Section 4.55(1A) Modification Application
to SSD 8209-
Site 4A, Oakdale South Industrial Estate,
Kemps Creek

Statement of Environmental Effects
Site 4A, Oakdale South Industrial Estate, Kemps Creek

Project Name _____ **Costco Mod 1**

Figure 39 – Changes to Roof plan (roof access) as notated and Clouded in Red.

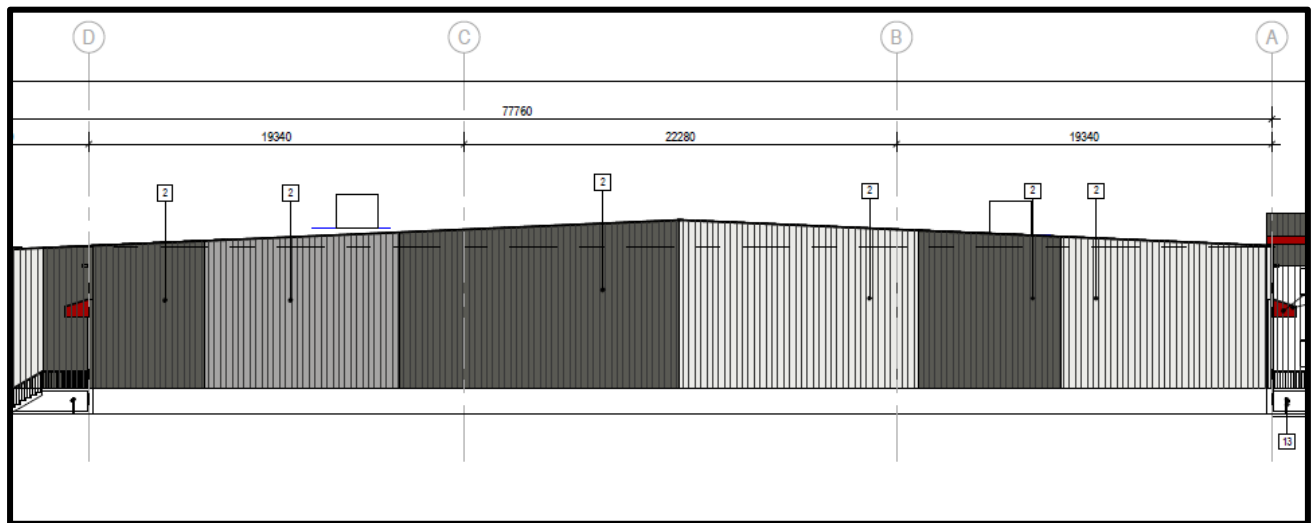
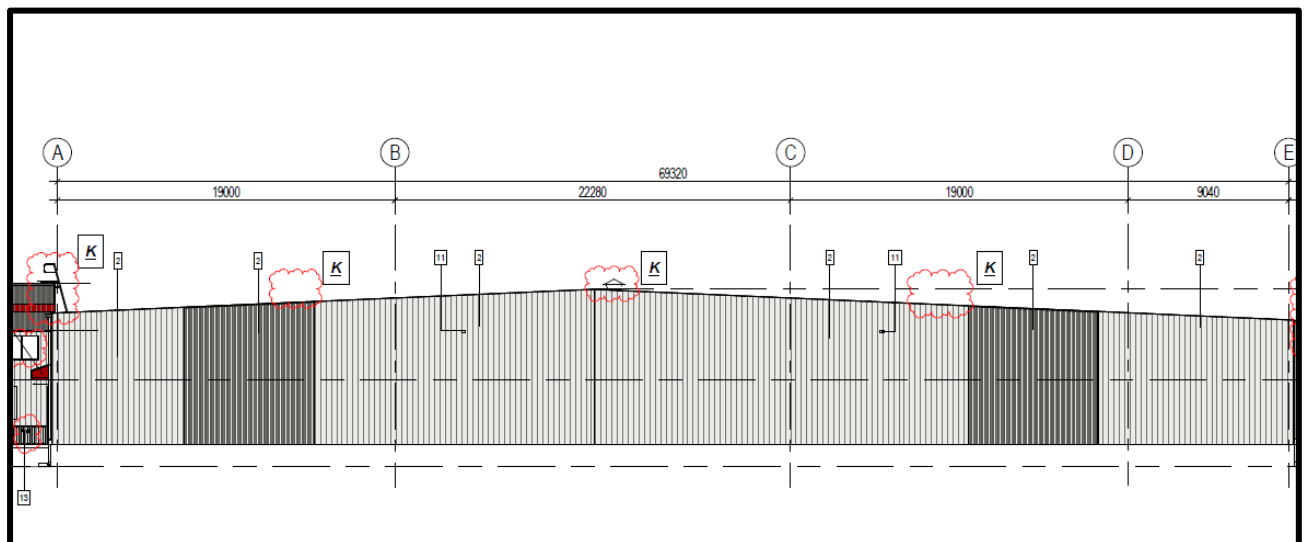
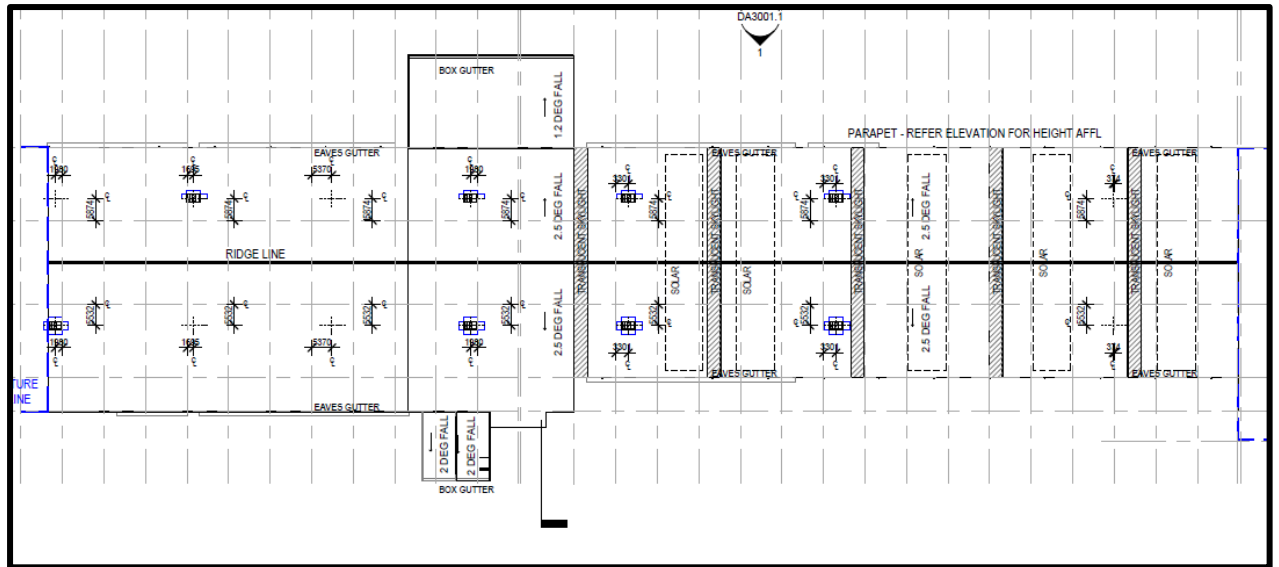
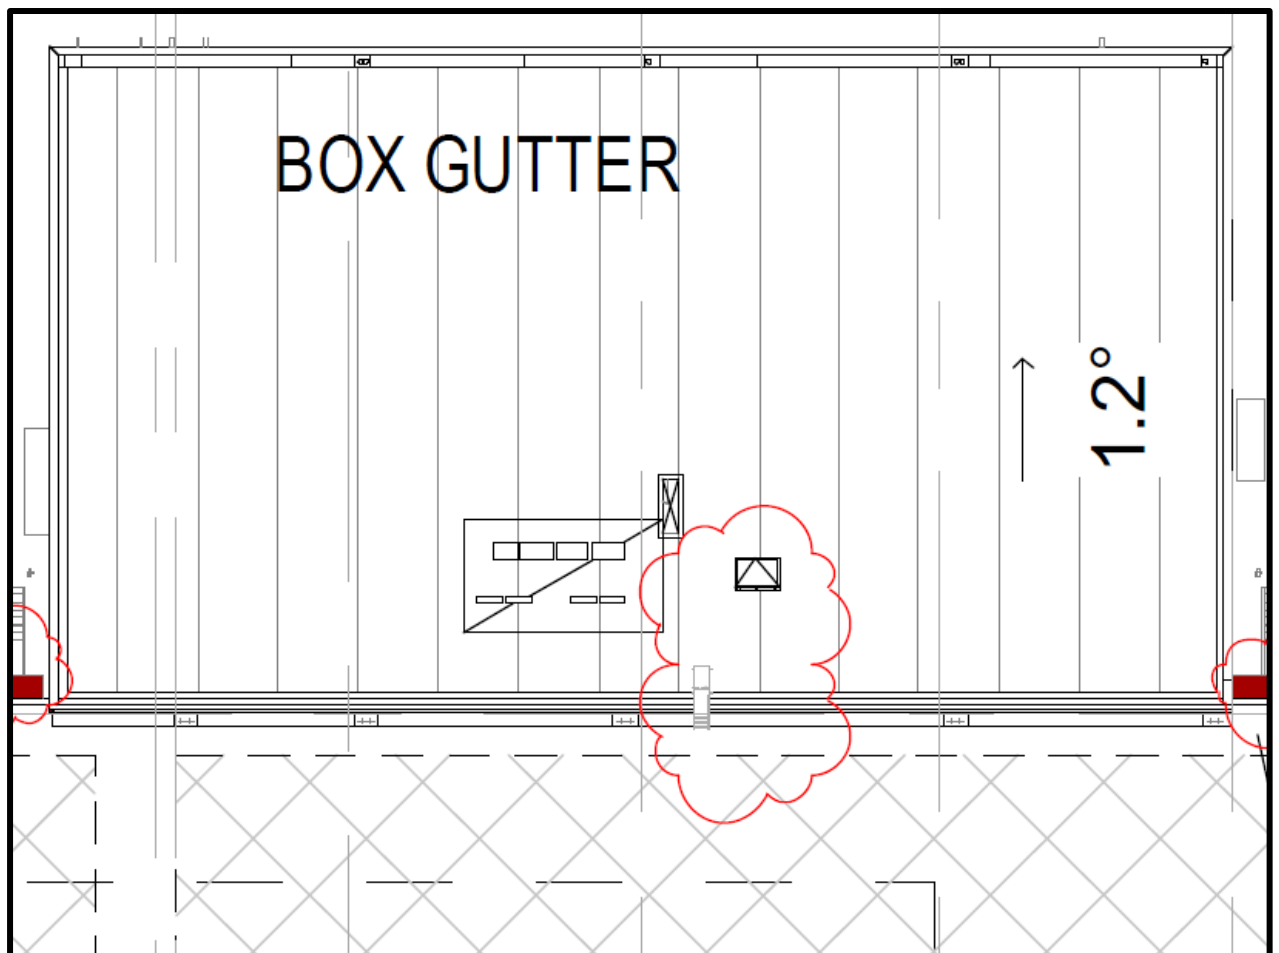
Proposed roof amendments as denoted as **(K)** on architectural plans. Specifically, these amendments include:

- i. Deletion of depot rooftop HVAC and skylights;
- ii. Provision of Rotary ventilation added atop of depot;
- iii. Proposed roof access between depot and office.
